APPLICATION NO.	FILING DATE	FIRST NAMED INVENTOR	ATTORNEY DOCKET NO.	CONFIRMATION NO.
10/778,020	02/17/2004	Hitoshi Tsuchiya	118489	6177
25944	7590	10/18/2005	EXAMINER	
OLIFF & BERRIDGE, PLC P.O. BOX 19928 ALEXANDRIA, VA 22320			NGUYEN, THANH NHAN P	
			ART UNIT	PAPER NUMBER
			2871

Office Action Summary	Application No. 10/778,020	Applicant(s) TSUCHIYA, HITOSHI	
	Examiner (Nancy) Thanh-Nhan P. Nguyen	Art Unit 2871

DETAILED ACTION

FIG. 33A

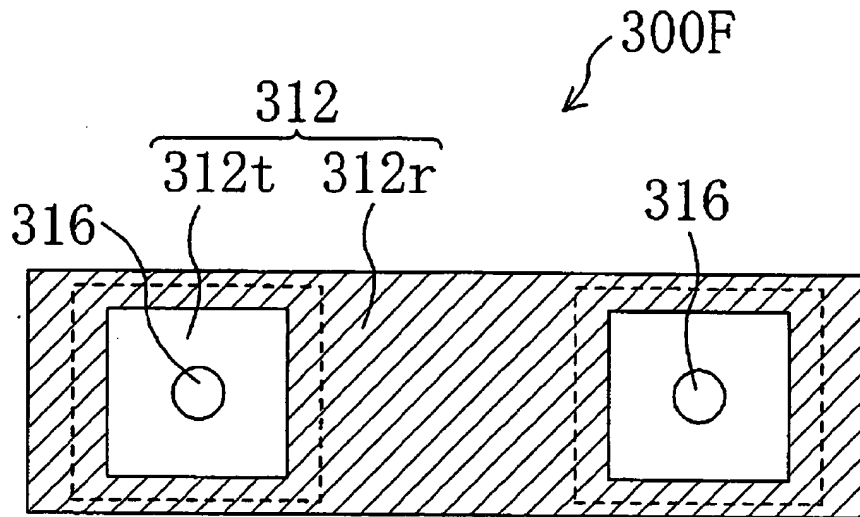
Referring to claim 1, Ogishima et al discloses a liquid crystal display device in figs. 33A-33B, comprising:

- a pair of substrates;
- a liquid crystal layer (330) sandwiched between the pair of substrates, the liquid crystal layer including liquid crystal with negative dielectric anisotropy;
- dot areas, each dot area having a reflective display area and at least two transmissive display areas;
- an adjusting layer (313) provided between the liquid crystal layer and at least one substrate of the pair of substrates, the adjusting layer making a thickness of the liquid crystal layer different in the reflective display area and the

transmissive display areas and being provided at least in the reflective display area; and

- an alignment restrictor (316) making the liquid crystal molecules in the transmissive display areas tilt, the tilting direction of the liquid crystal molecules being opposite to each other in the two transmissive display areas (considered the transmission area A having liquid crystal molecules tilt opposite the direction of the liquid crystal molecules in the transmission area D; and the transmission area B having liquid crystal molecules tilt opposite the direction of the liquid crystal molecules in the transmission area C; see fig. 33B from the attachment – emphasis added), the alignment restrictor making liquid crystal molecules of the liquid crystal layer tilt in the same direction in the reflective display (since the liquid crystal display device of Ogishima et al is a liquid crystal display device of a vertical orientation mode in which the liquid crystal layer is substantially in a vertical orientation state under application of no voltage, the liquid crystal molecules tilt in same direction (substantially vertical to the substrates) in the reflective display area; see fig. 33B from the attachment – emphasis added -- and par. 0033 from the reference].

- the adjusting layer having a slope (306) in the vicinity of a boundary between the reflective display area and the transmissive display areas;
- an electrode (322, 312 (312t, 312r)) that drives the liquid crystal being provided on each internal surface of the pair of substrates;

- and the alignment restrictor (316) having at least one of a slit opening and a projection formed in the electrode (312t), [see fig. 33B].

Applicant's arguments filed 8/3/2005 have been fully considered but they are not persuasive. Therefore, the previous office action rejection has been maintained. Examiner also provides an attachment in this office action for better view of the explanation in the rejection.
